Sample Approval Form

Customer: Energy King
Attention: Mike Kolz
CSR: Helena Botelho

Die #: 15296
Description: D.H. Jamb w/ Nailing Fin

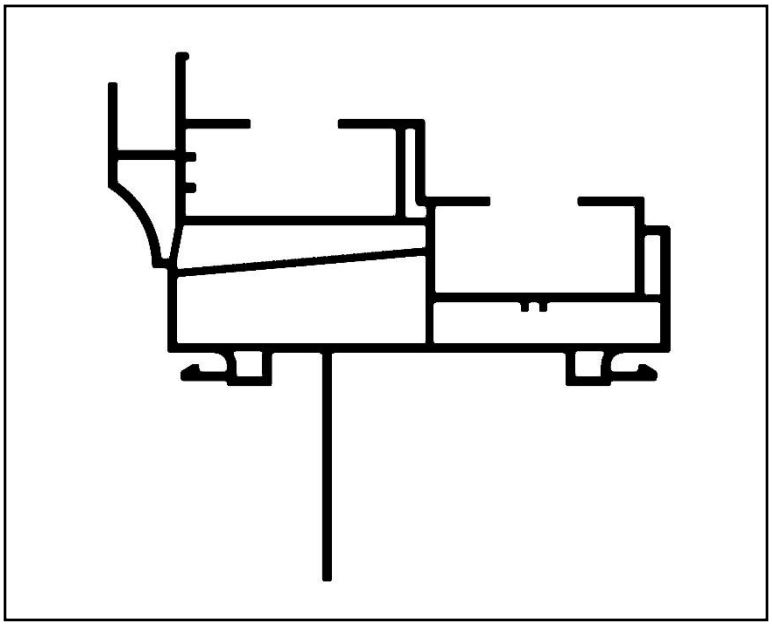
Comments: The closed in legs for the balance pocket causes us issues with the tilt latch locations.
The mull track causes us some issues with the weld fixtures and notch box.
